# Value Engineering Study No. 201905 – Report

**KY 80 and KY 461 Interchange and KY 461  
Widening**

*Pulaski County*

December 16 through 19, 2019

**VE RECOMMENDATION NO. 1:  
USE ROUNDABOUTS AT INDUSTRIAL PARK BRIDGE**

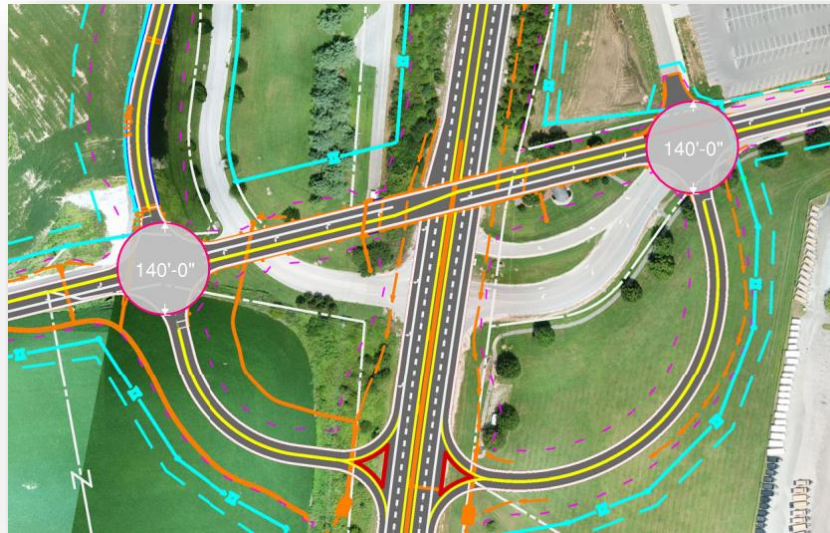
Constructing roundabouts at the jug handle intersections along Coin Road and Valley Oak Drive would allow the proposed Coin Road bridge to be reduced to two lanes as opposed to the current proposed condition of a three lane cross section. Roundabouts at either junction point would remove the need for the alternating left-turn storage across the bridge to serve the two intersections. This could reduce the width of the proposed bridge by 14 feet.

This width can be accommodated at both intersections. The sketch below shows two sample 140-foot diameters, which can fit within the project right-of-way.

**VE RECOMMENDATION NO. 2:  
 CHANGE STRUCTURE DESIGN AT SYSTEM  
 INTERCHANGE**

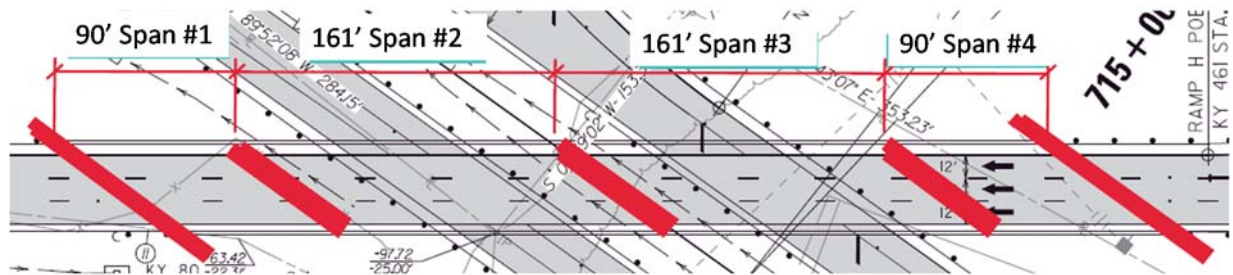
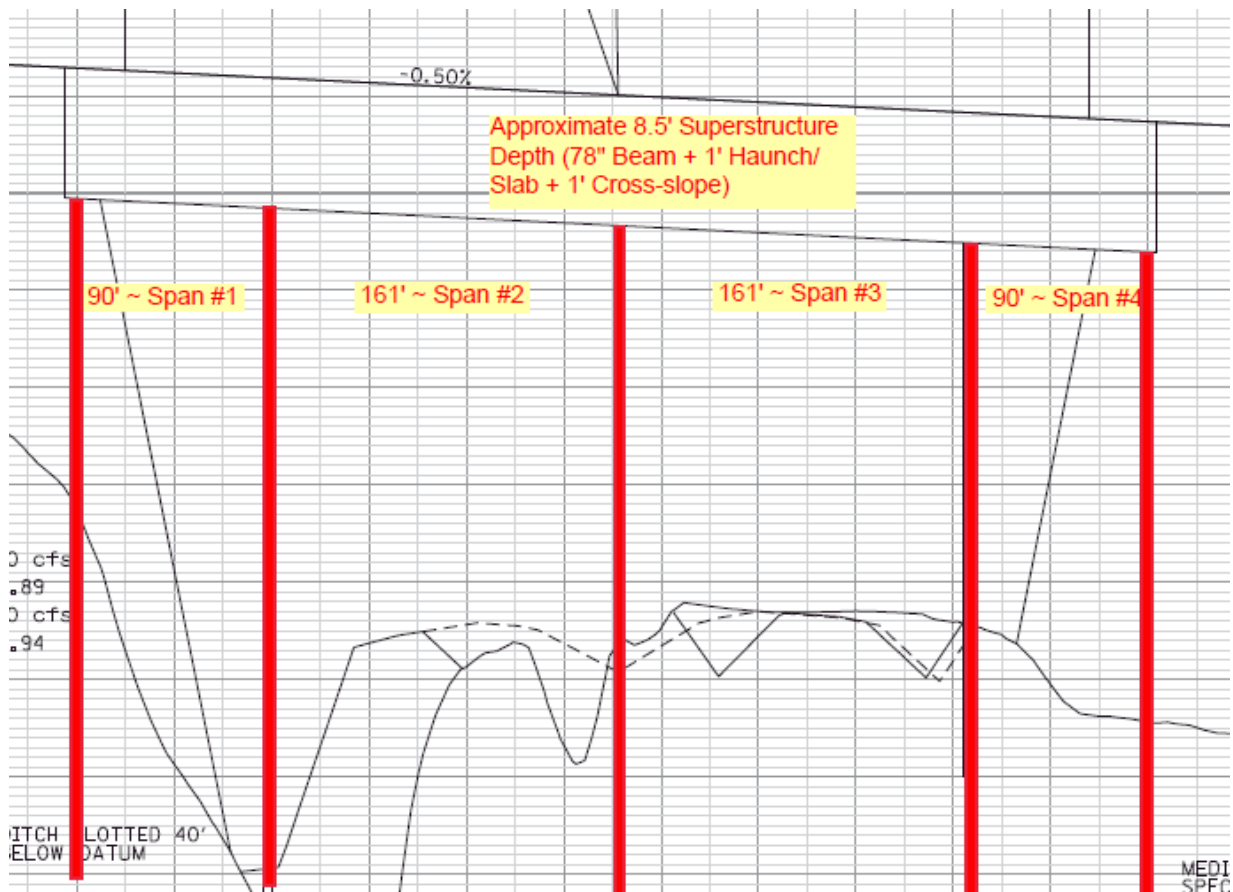
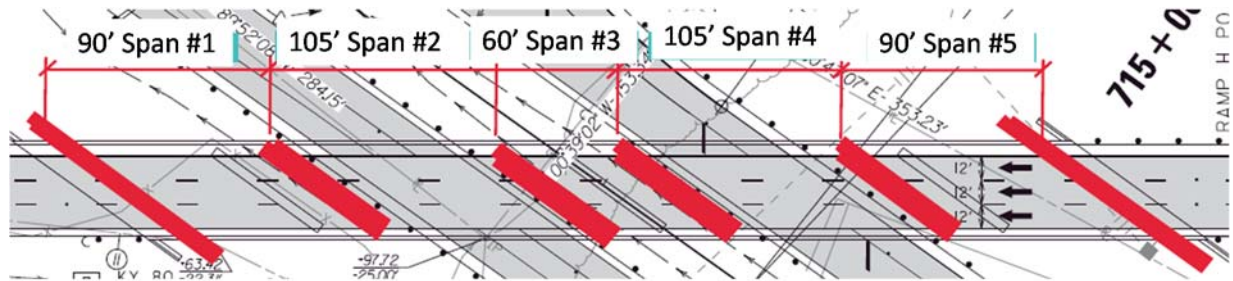
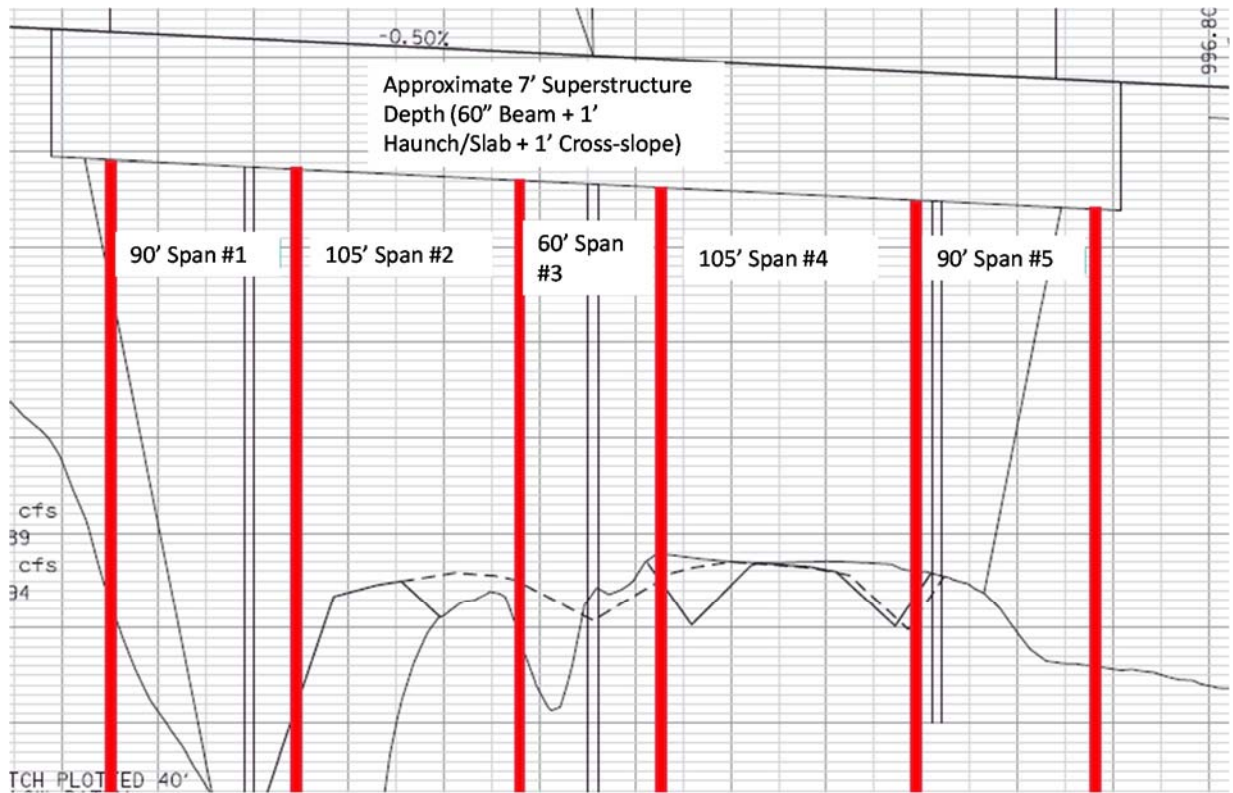
<b>VE RECOMMENDATION NO. 2: CHANGE STRUCTURE DESIGN AT SYSTEM INTERCHANGE</b>		<b>Idea Nos. 29, 31</b>		
<b>Baseline Concept</b>				
<p>The baseline condition proposes twin 4-span bridges that cross over three lanes in each direction. There is guardrail located behind the shoulders on each side of the traveling lanes. Each bridge has a span configuration of 90'-161'-161'-90'. The bridge superstructures will either consist of plate girder structures or hybrid concrete box beams.</p>				
<b>Recommendation Concept</b>				
<p>Revise the bridge to a 5-span configuration of 90'-105'-60'-105'-90'.</p>				
<b>Advantages</b>		<b>Disadvantages</b>		
<ul style="list-style-type: none"> <li>• Lower maintenance</li> <li>• Lower cost</li> <li>• More conventional beam type</li> <li>• May permit decrease in profile and embankment</li> <li>• Lighter weight beam permits contractor to use a smaller crane</li> </ul>		<ul style="list-style-type: none"> <li>• Additional substructure element required</li> <li>• Revised span configuration could yield uplift in middle span</li> </ul>

Use two piers in the median, locate each behind the proposed guardrail and modify the span configuration to a 5-span with 90'-105'-60'-105'-90'. The revised configuration would permit the use of more traditional concrete beams such as an AASHTO Type IV or AASHTO Type V Beam.

**Minor Street Approaches**

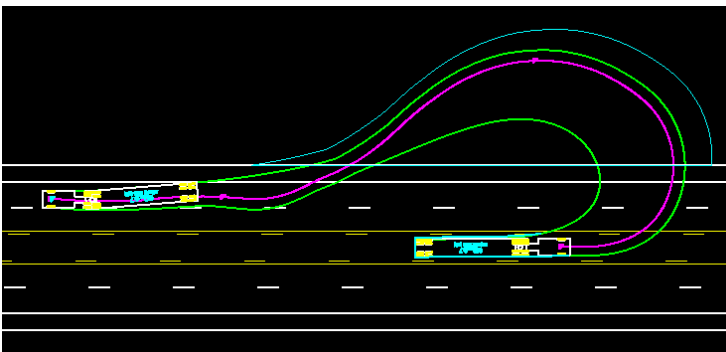
Throughout this area, the minor street/driveway approaches typically provide access to a small number of homes or businesses and thus are not anticipated to generate significant traffic volume. Thus restricting movements should not incur significant delay. Additionally, the out-of-direction travel for U-turn vehicles should only impact a limited number of vehicles. Barrier walls also deter future full-directional access points along the corridor.

**Technical Discussion/Sketches**

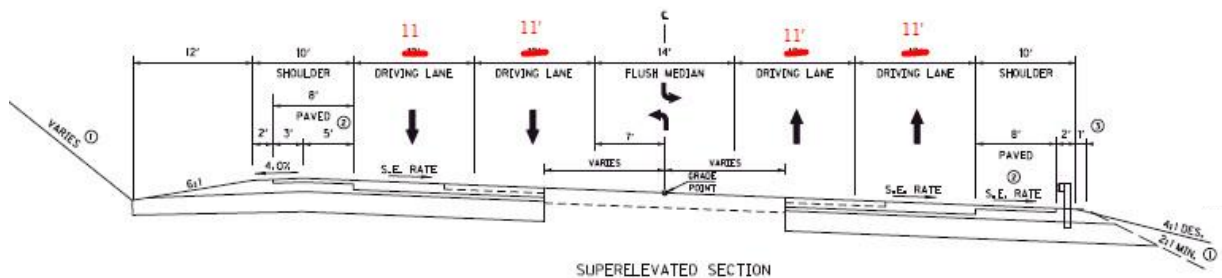
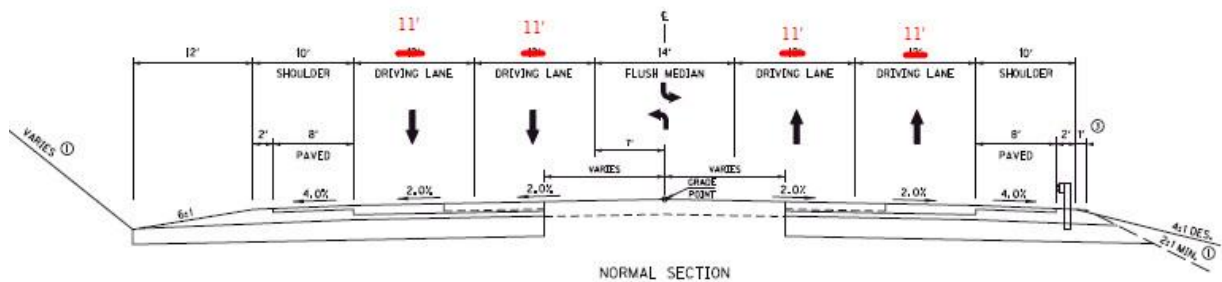
The VE team recommends using four 11-foot lanes instead of four 12-foot lanes for the entirety of the project. By using 11-foot lanes, overall pavement costs and long-term maintenance costs can be reduced due to less material used and decreased asphalt resurfacing needed.

**Initial Configuration as part of this project**

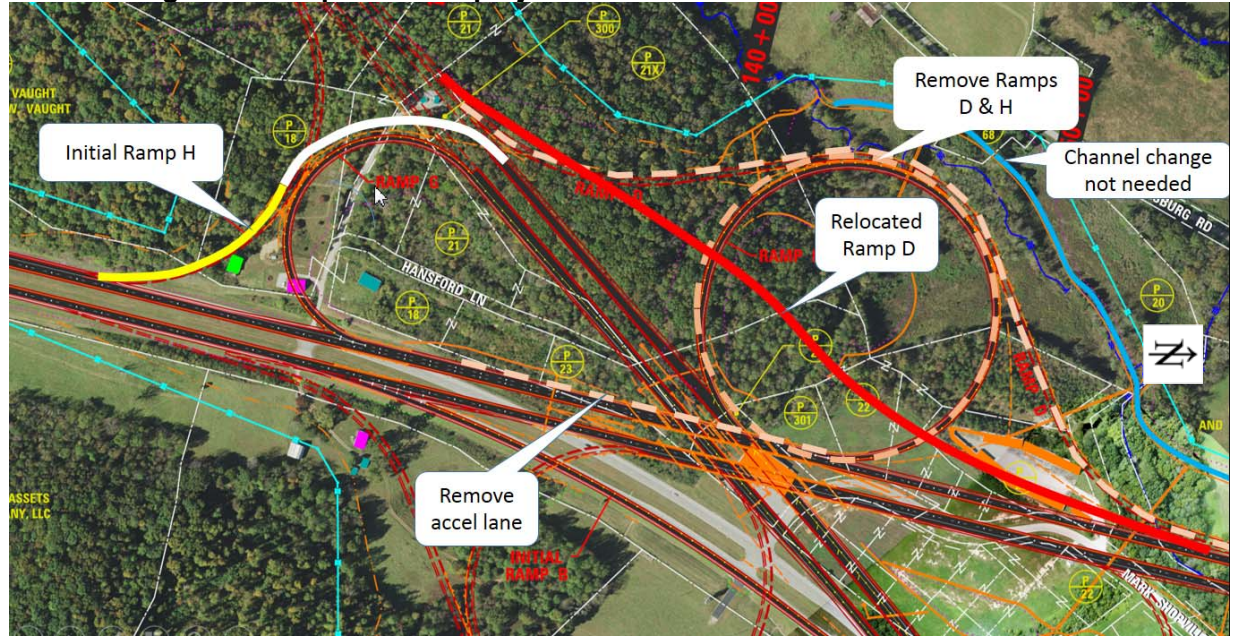
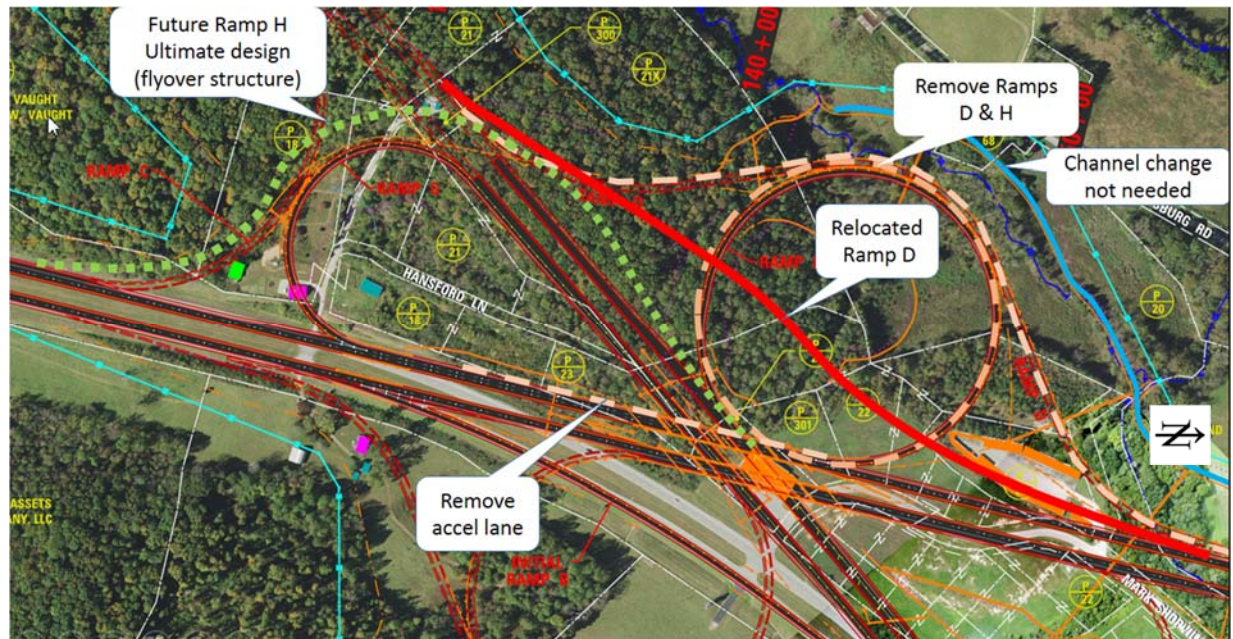
<b>VE RECOMMENDATION NO. 7: RECONFIGURE RAMP D</b>		<b>Idea No. 11</b>		
<b>Baseline Concept</b>				
Ramp D is a loop ramp carrying westbound KY 80 to southbound KY 80 traffic.				
<b>Recommendation Concept</b>				
As part of an initial design for this project, build Ramp D as a left hand movement that ties into Ramp C. Plan for building a Ramp D flyover when the Somerset Northern Bypass project advances.				
<b>Advantages</b>		<b>Disadvantages</b>		
<ul style="list-style-type: none"> <li>• Significantly reduces cost for current project</li> <li>• Less pavement</li> <li>• Eliminates a weave movement at interchange</li> <li>• Eliminates stream impacts</li> <li>• Reduces bridge width</li> <li>• Reduces right-of-way requirement</li> </ul>		<ul style="list-style-type: none"> <li>• Significant redesign</li> <li>• Additional structures in future</li> </ul>		
<b>Cost Summary</b>		<b>Capital Cost</b>		<b>Life Cycle Costs</b>

<b>VE RECOMMENDATION NO. 8:          MARK SHOPVILLE RIGHT-OUT ONLY AT KY 461</b>	<b>Idea No.          14</b>
--	---------------------------------

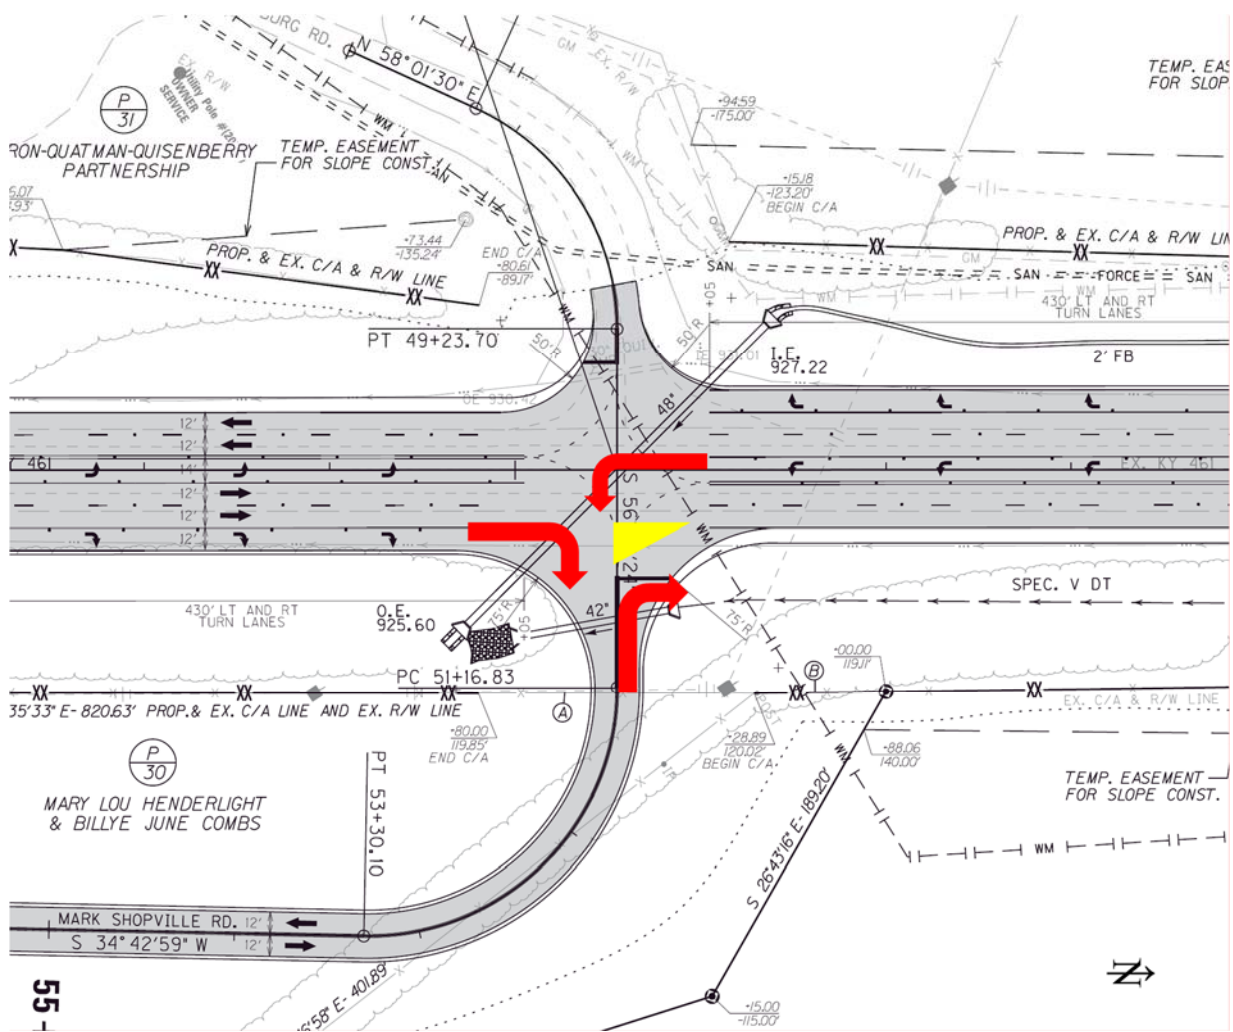
Once constructed, the baseline design allows traffic flow on Mark Shopville Road to have a left-out and right-out movement. The VE recommendation is to only allow traffic on Mark Shopville Road to have a right-out movement. Traffic on KY 461 would still have access to make a right-in and left-in. A concrete island or something similar would be implemented to constrain left-out movement.

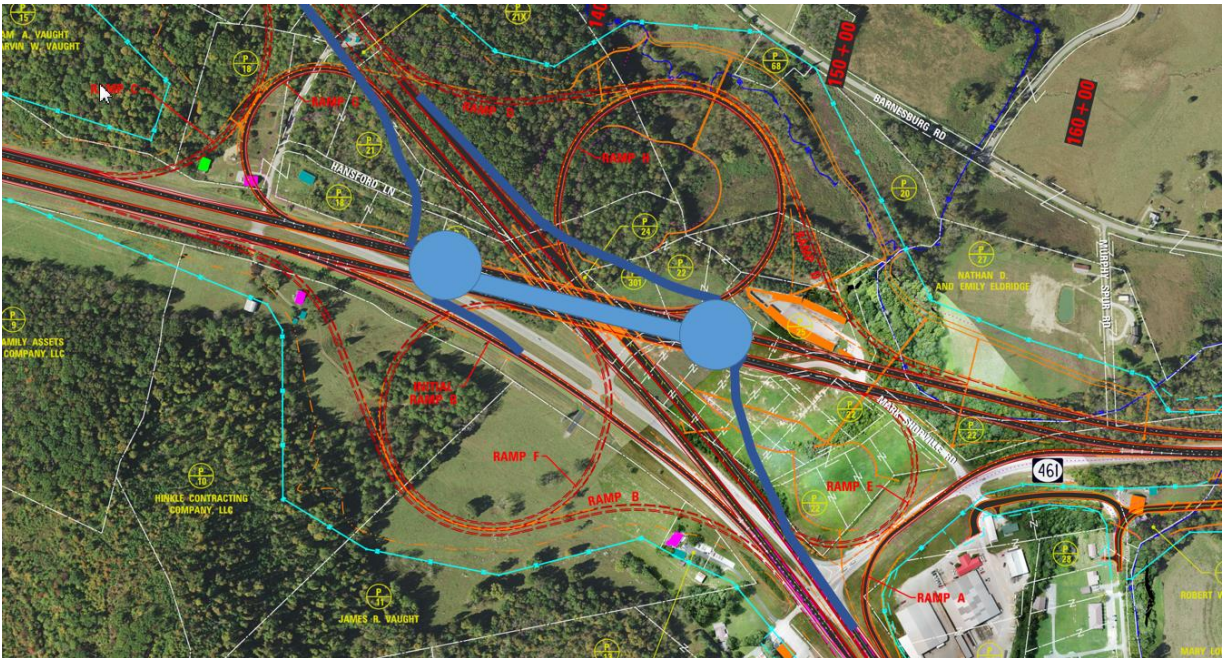
<b>Discussion</b>		
<p>Utilizing 2+1 lanes is an attractive alternative to four-lane roads where environmental and/or fiscal constraints make provision of a four-lane facility impractical. A 2+1 facility should also only be used in level or rolling terrain, and this project location has rolling terrain. However, the location of major intersections and high volume driveways should be a key consideration when selecting passing lanes. Proper placement of passing lanes and transition sections with respect to higher volume intersections will minimize the number of turning movements within the passing lane sections. Major intersections should be located in the transition area between opposing passing lanes and the conventional left-turn lanes provided at the intersection (<i>A Policy on Geometric Design of Highways and Streets</i>, 3-149 to 3-152).</p> <p>With eight entrances on this section of KY 461, rear-end accidents of left-turning vehicles from passing lanes is of concern. To accommodate this, appropriate placement of passing lanes and transitions can be employed. J-turns and U-turn movements could also be implemented to restrict left turn movements. In this roadway section of approximately 1.95 miles, two passing lane sections could be constructed, considering taper lengths, lane drop lengths, and passing lengths.</p> <p>This 2+1 concept can also accommodate future growth of the area. The roadway can be reconfigured through re-striping or construction of an additional lane.</p> <p>The total width of the roadway would also be reduced from 82 feet to 59 feet, reducing cost, maintenance, and environmental impacts.</p>

**DESIGN CONSIDERATION NO. 15:  
ADD AN EASTBOUND BARNESBURG TO NORTHBOUND 461  
ACCELERATION LANE**

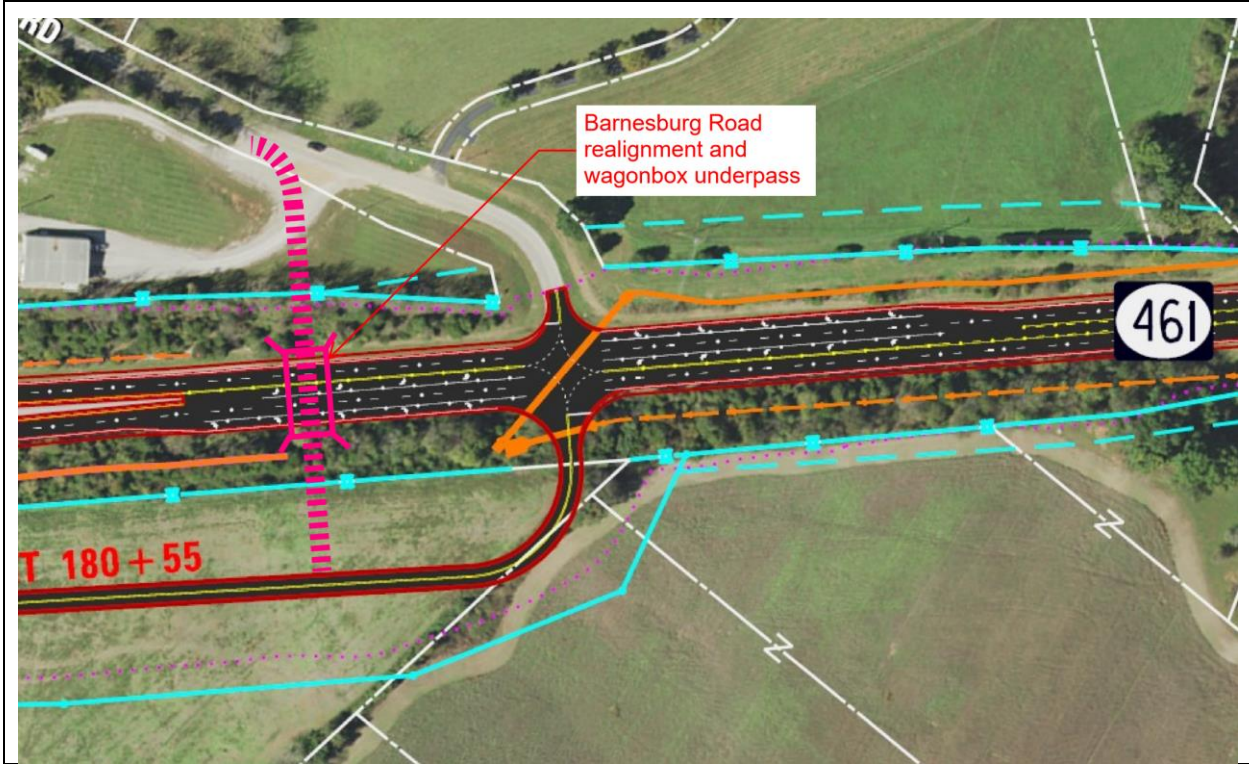
<b>DESIGN CONSIDERATION NO. 15: ADD AN EASTBOUND BARNESBURG TO NORTHBOUND 461 ACCELERATION LANE</b>		<b>Idea No. 17</b>
<b>Baseline Concept</b>		
As designed, to make a left turn from Barnesburg Road onto KY 461 vehicles must cross a right-turn lane, two through-lanes, and a left-turn lane. Vehicles will have no refuge area and must make the complete turn onto the left-most northbound KY 461 lane.		
<b>Suggested Concept</b>		
The recommended concept is to add an eastbound Barnesburg to northbound KY 461 acceleration lane.		
<b>Advantages</b>		<b>Disadvantages</b>
<ul style="list-style-type: none"> <li>• 2 stage gap acceptance</li> </ul>	<ul style="list-style-type: none"> <li>• Requires more pavement</li> <li>• Traffic volume may not warrant</li> </ul>	
<b>Discussion</b>		
<p>Adding an acceleration lane for vehicles turning left from Barnesburg Road onto KY 461 would give these vehicles distance and time to fully accelerate to the speed of main line traffic. With the current design, left-turning vehicles from Barnesburg onto KY 461 would need a 9 second time gap to safely perform the turn (per the <i>Policy of Geometric Design for Highways and Streets</i>). Along with this, drivers must judge the time needed to not only cross traffic, but safely turn into free-flow traffic in one stage. Adding an acceleration lane would break this process into two stages, which gives vehicles turning extra time to reach free-flow speeds and safely merge into traffic. Adding an acceleration lane could require more right-of-way acquisition because a portion of the road would need to be widened 12 additional feet. Cost would be increased slightly with the addition of pavement. Below is a graphic depicting the new lane configuration at Barnesburg:</p>

New Edge-of-Pavement	Extend currently designed auxiliary lane for Ramp A past intersection with Barnesburg	Extend median to intersection to accommodate for lane shift
Shift all lanes (left turn, two through, right turn) to the east by 12 feet	Use current left-most through lane as acceleration lane and new lane for through movement	Taper lanes back to designed alignment
<p>Another alternative to an acceleration lane, which would also aid in the difficult left-turn movement, would be to construct a culvert under KY 461 and re-route Barnesburg Road under KY 461 onto the newly proposed section of Mark Shopville Road. The underpass may need to be located further to the west due to grades. On the following page is a graphic depicting this design layout:</p>
